ADDENDUM #3
January 29, 2025

TO: ALL Prospective Bidders
PROJECT: KTC ADA Compliance Modifications & Bathroom Upgrades
BID REFERENCE #: 91065-008.0
BID OPENING DATE/TIME: **February 19, 2025 @ 3:00 p.m. Local Time (ET)**

**KTC ADA Compliance Modifications & Bathroom
Upgrades**

ADDENDUM NO. 3

LANDSCAPE PLAN
1" = 20'-0"

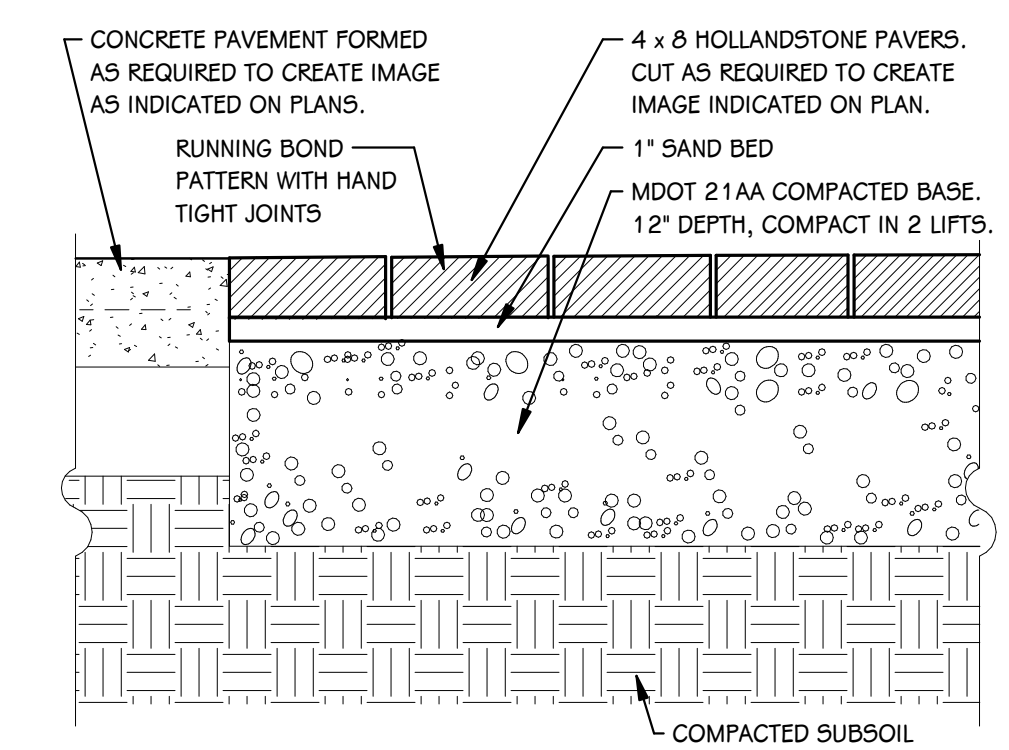
QUESTION 13: On L101 there is a picture labeled 15, but there is no landscaping note 15. What line does this picture belong to?

QUESTION 14: What is broken on the utility panel (L101/11)?

ADD-1 Item No. D-1 - Refer to re-issued drawing L 101 [clarifications]

Modified Note 11 to read: "replace ground box with new 6x6 ground box cover

Modified Note 14 to include reference to photo 15

ANSWER 13: 14 and 15 are photos of the same condition. Please see Attachment A

ANSWER 14: The panel cover needs to be replaced. Provide 6x6 ground water box. Please see Attachment A.

- FIX ANY BRICK WITH LARGER THAN 1/4" VERTICAL VARIANCE
- FIX ANY BRICK WITH LARGER THAN 1/4" VERTICAL VARIANCE
- REPLACE GROUND WATER BOX WITH NEW 6X6 GROUND BOX COVER

1 ENLARGED FIRST FLOOR PLAN
1/4" = 1'-0"

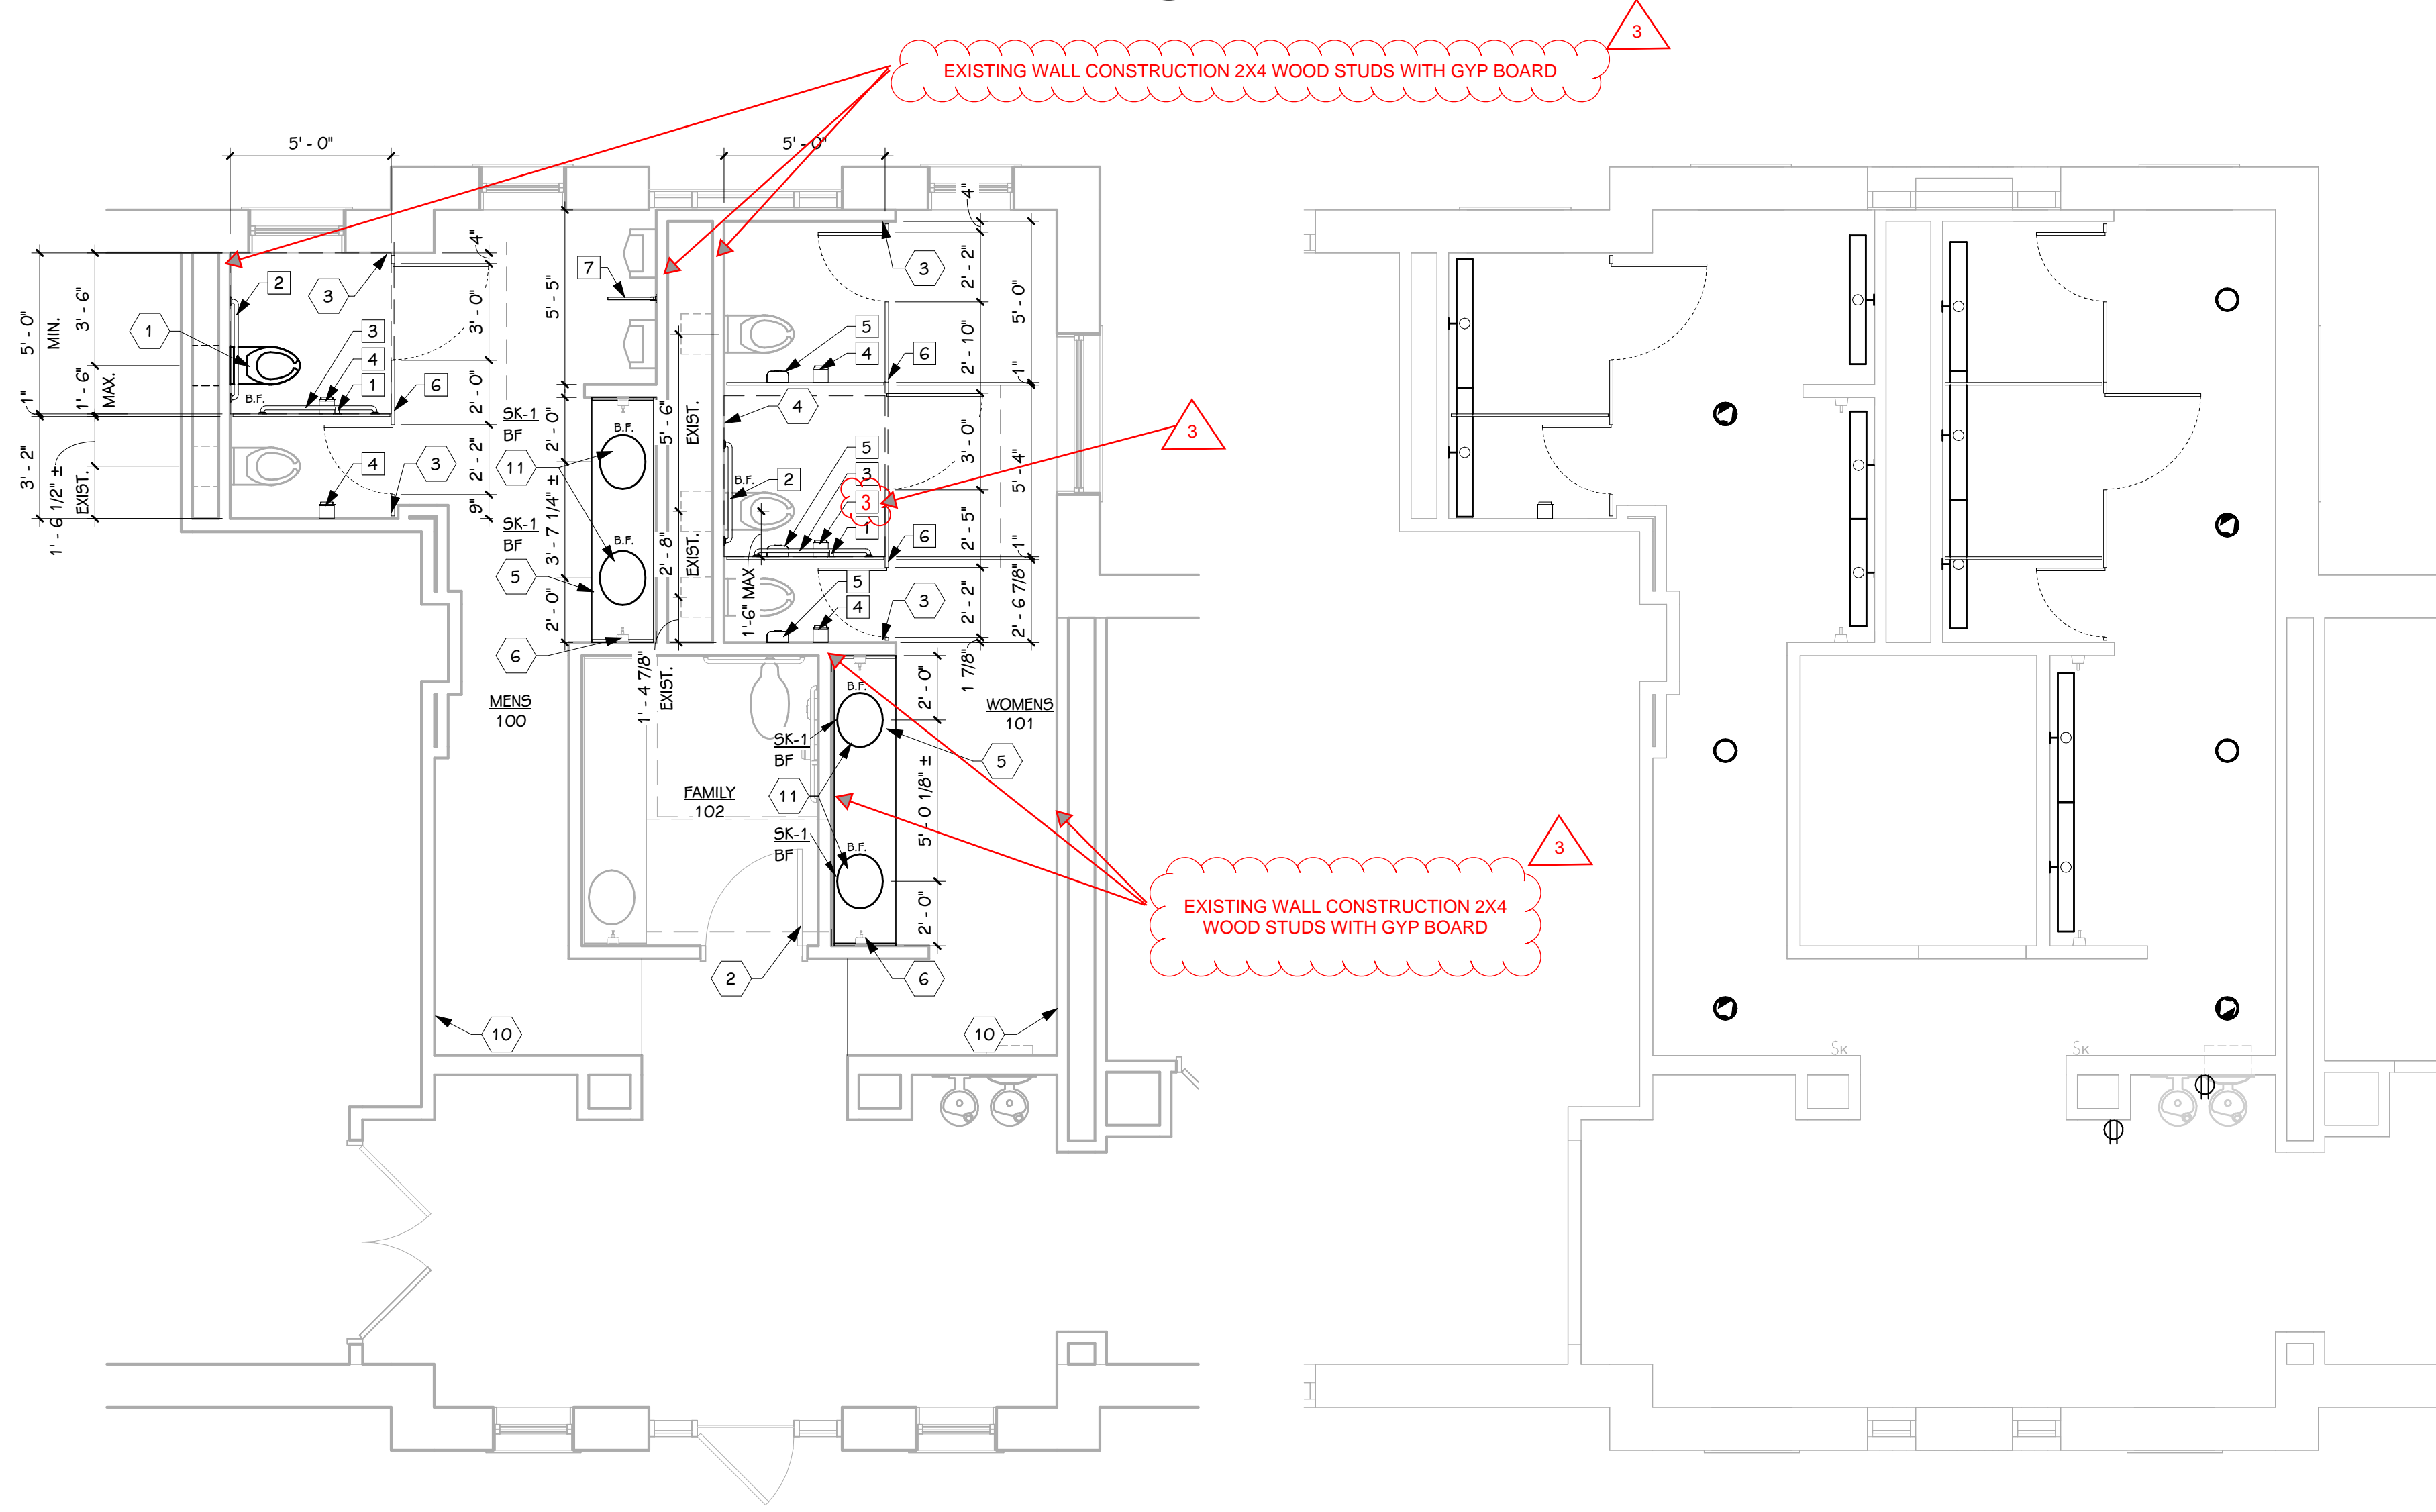
QUESTION 1: I am looking at this project and there are no plumbing specs for the lavatories that are being swapped out. What faucets are going back in? Are the sinks integral and by others or is there a spec we can get for them? The water closets are called to be pulled and reset. Are you wanting an allowance for new included? If so, what is currently installed vs what is desired?

QUESTION 2: On sheet A101, the second Woman’s stall calls for the installation of two sanitary napkin holders, toilet accessory note 5, but points to a toilet paper holder. Please advise.

ADD-1 Item No. D-3 - Refer to re-issued drawing A 101 – Existing Wall Construction

From the remodeling drawings from 2004, it appears the existing walls in the toilet rooms are constructed with wood studs and drywall.

ADD-1 Item No. D-4 - Refer to re-issued drawing A 101 – Sink and Faucet

ANSWER 1: Please see Attachment A: “ADD-1 Item No. D-4”

ANSWER 2: Will change note 5 pointing to dispenser to note 4. Please see Attachment A

Added sink and faucet info under keyed note 11:

SINK: AMERICAN STANDARD OVALYN 0495.221 WHITE UNDER COUNTER SINK OR EQUAL

FAUCET: CHICAGO MANUAL FAUCET MVP 802-VE2805-665ABCP OR EQUAL

NEW FIXTURE:
AMERICAN STANDARD OVALYN 0495.221 WHITE UNDER COUNTER SINK OR EQUAL/CHICAGO MANUAL FAUCET MVP 802-VE2805-665ABCP OR EQUAL
